PRESENTATION ON PEER REVIEW,
SUPPLEMENTAL INVESTIGATION AND
SEEPAGE ANALYSIS
FOR
KINGSTON FOSSIL PLANT, DREDGE CELL
KINGSTON, TENNESSEE

Prepared for
Tennessee Valley Authority

Prepared by
GeoSyntec Consultants

April 2005

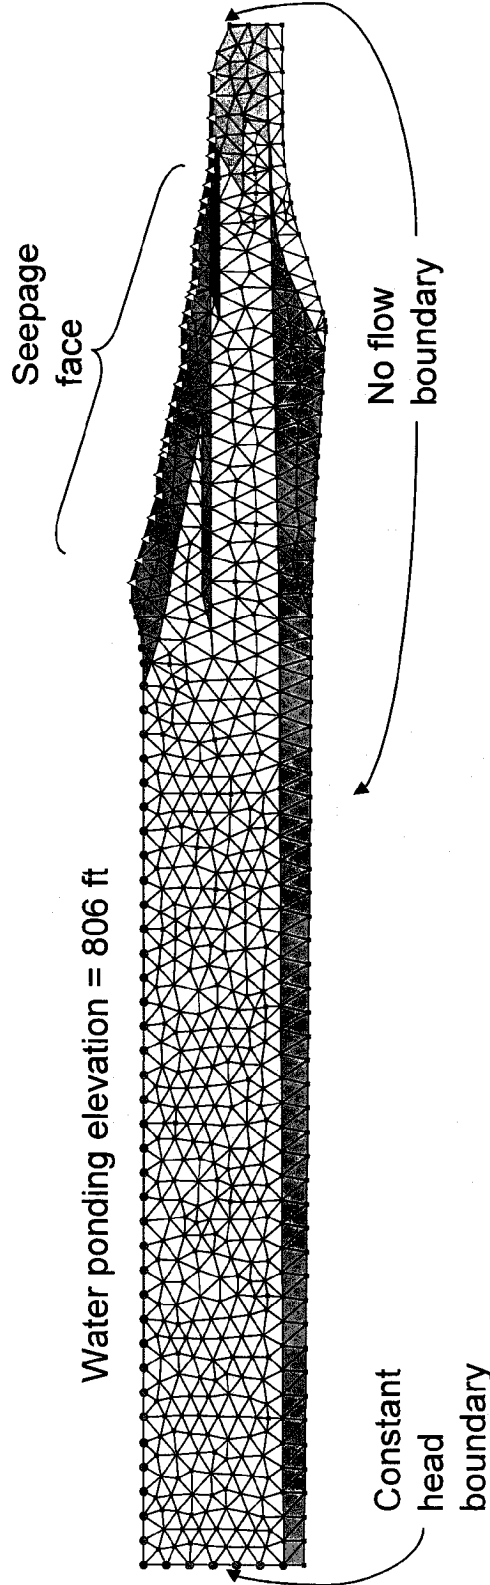
- Analytical results of Case 1 are in close agreement with total head measurements recorded in the field during the January 2005 site investigation.
- This analysis provides a good calibration for model input parameters (e.g., hydraulic conductivity). Close agreement between model-predicted and field observations provides an appropriate level of confidence in input parameters used.
- Input parameters specified in this analysis (i.e., material properties) were therefore used in subsequent analyses cases.

Case 2 (Blow-out condition) SEEP/W Output Summary

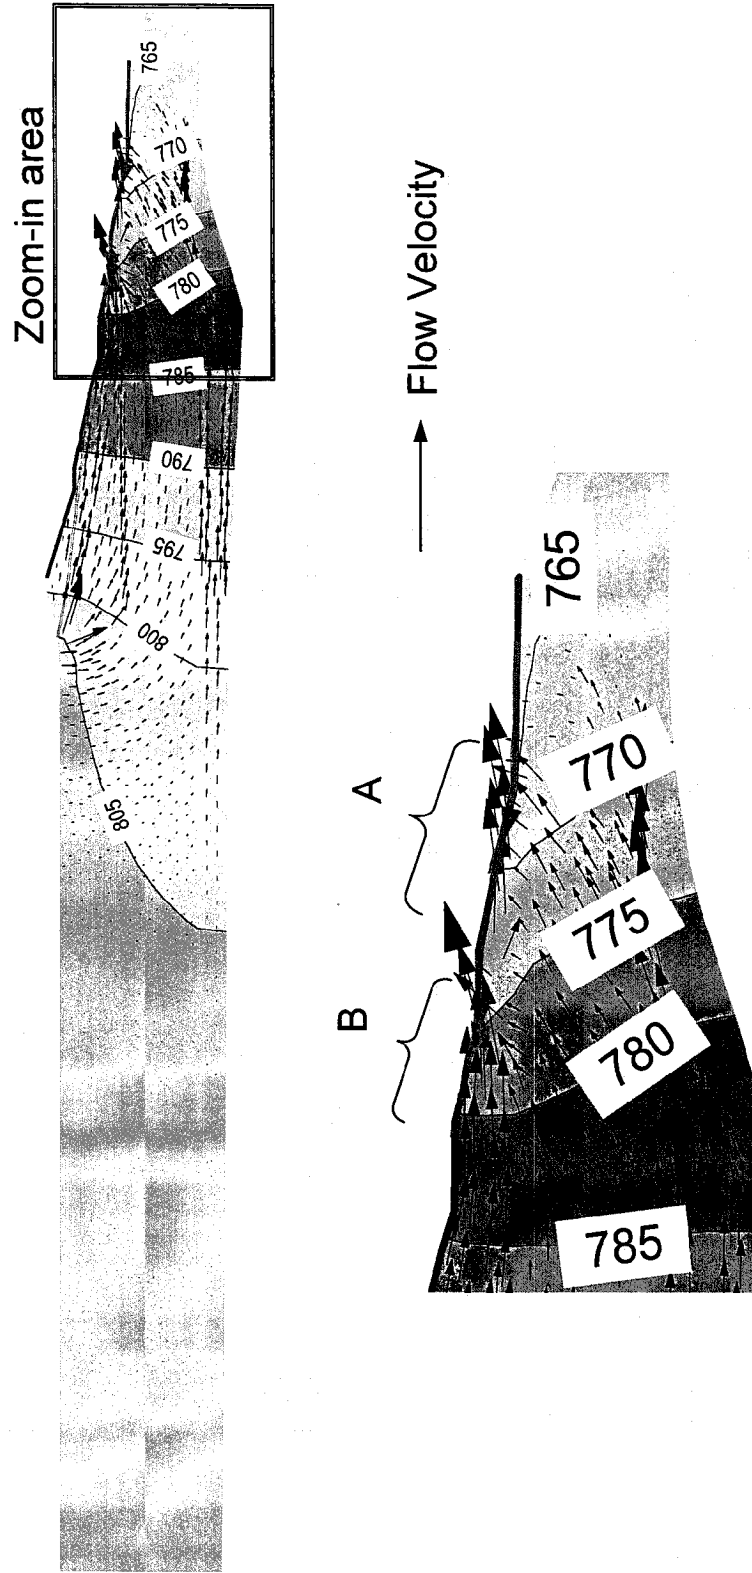
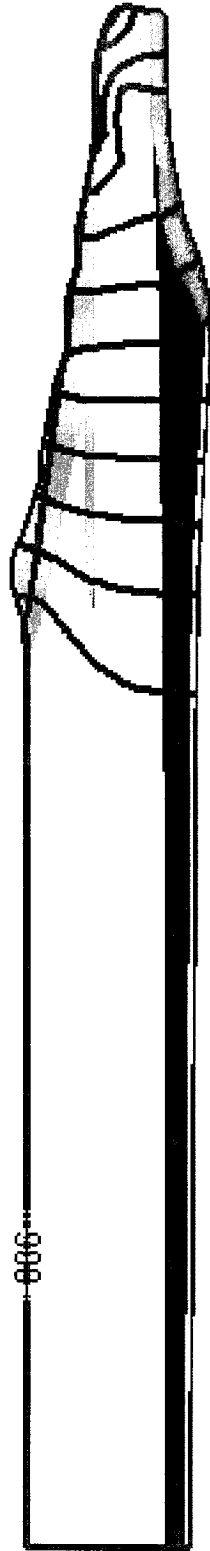
- The computed hydraulic gradient at the lower portions along exit face 'A' is greater than the critical hydraulic gradient, confirming the likelihood that piping and blow-out will occur consistent with that observed in field.
- Model-predicted location of blow-out (i.e., exit face 'A') coincides with blow-out location observed in the field (i.e., at elevation 766 ft MSL).
- Qualitative assessment of analysis results performed for blow-out condition (Case 2) are consistent with visual observations reported in the field (e.g. wet spots on slope, vegetation on downstream slope and estimated quantity of seepage through the blow-out area).

Proposed Improvement

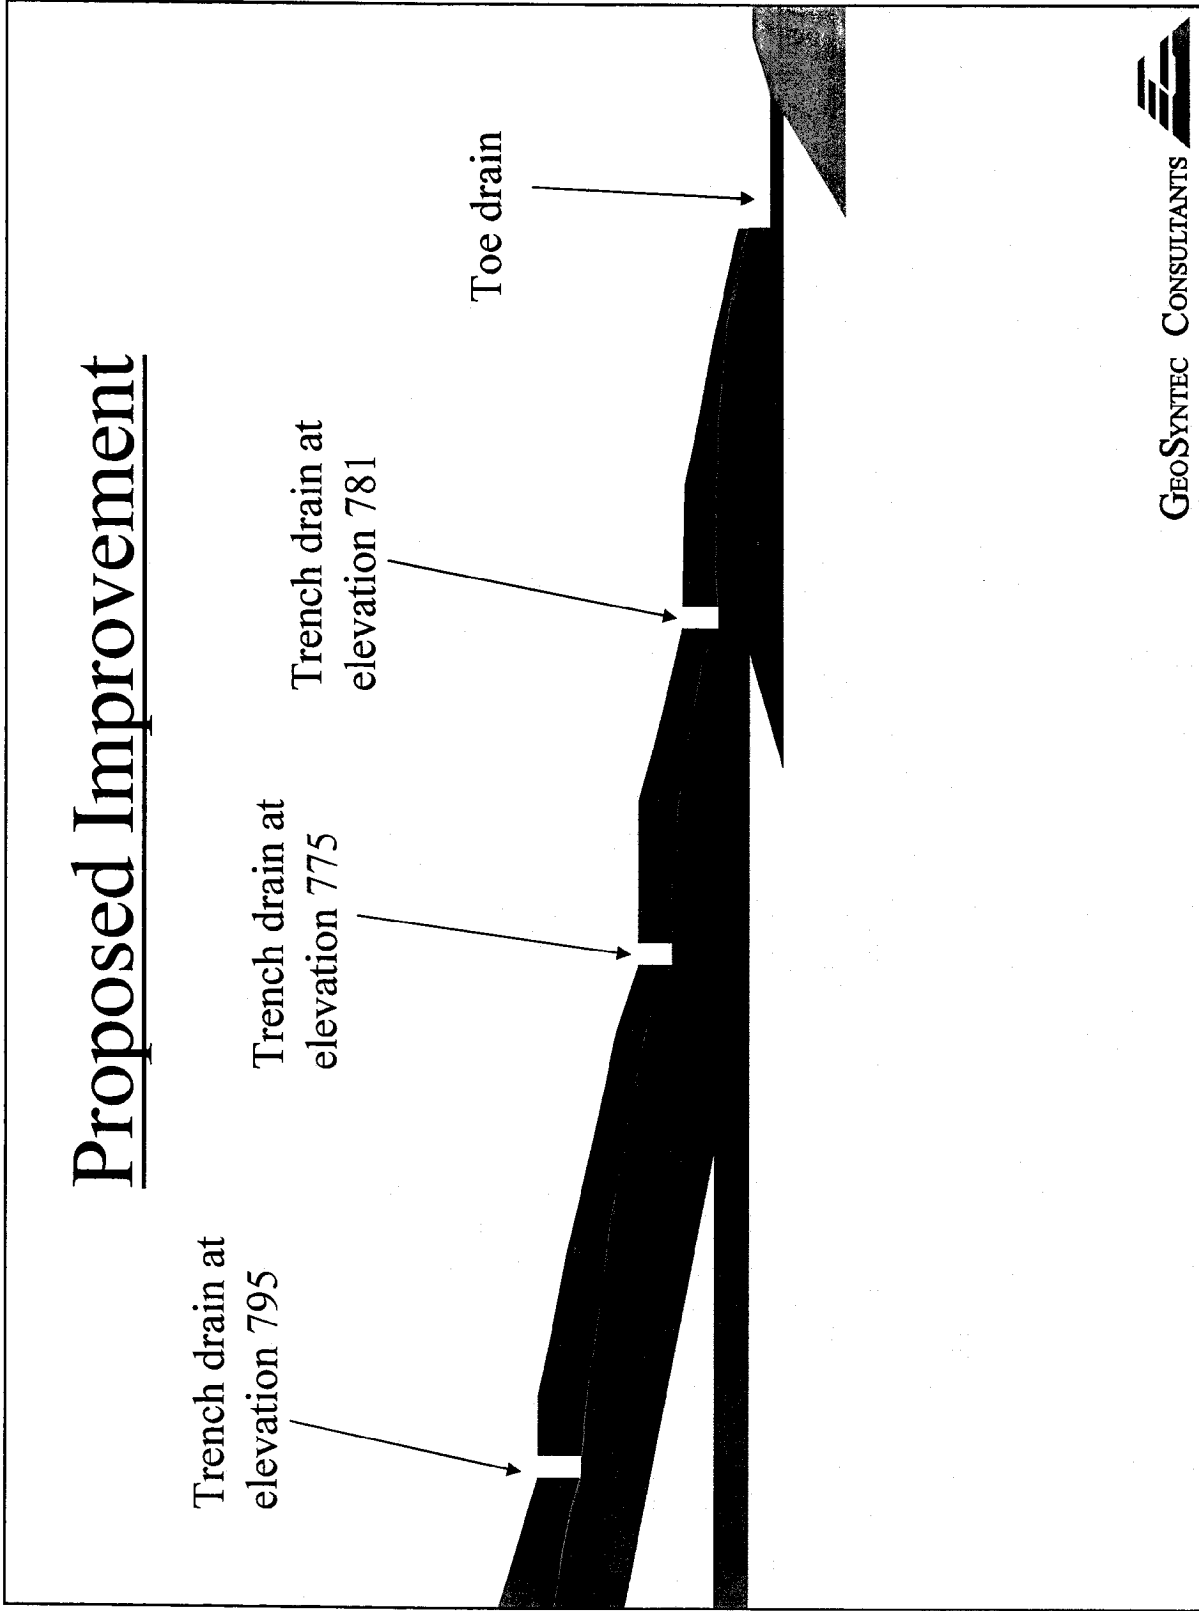
- As indicated from the analytical results of Case 2 (blow-out condition), blow-out resulted from the development of internal pore water pressure on the face of the slope that caused piping to occur that led eventually to excessive seepage.
- To prevent further piping action and to maintain the stability of the outer slopes, several improvement features need to be incorporated in the future design.
- The design prepared by Parsons will incorporate a series of underdrains located at successive elevations within the outer dike.
- The Project Team have considered several improvement options. These options were evaluated on the basis of: (i) effectiveness to reduce pore pressure at the downstream slope; and (ii) ability to reliably construct/implement.

The proposed improvements for the lower portion of the dredge cell side slope consists of the following major items:

- A trench drain constructed to a minimum depth of 6 feet deep from the existing bench at EL 795 feet
- A trench drain constructed to a minimum depth of 5 feet deep from the existing bench at EL 781 feet
- A trench drain constructed to a minimum depth of 5 feet deep from the existing bench at EL 775 feet
- A buttress type toe drain pipe with minimum rip rap lining to the existing drainage channel adjacent to Swan Pond Road.
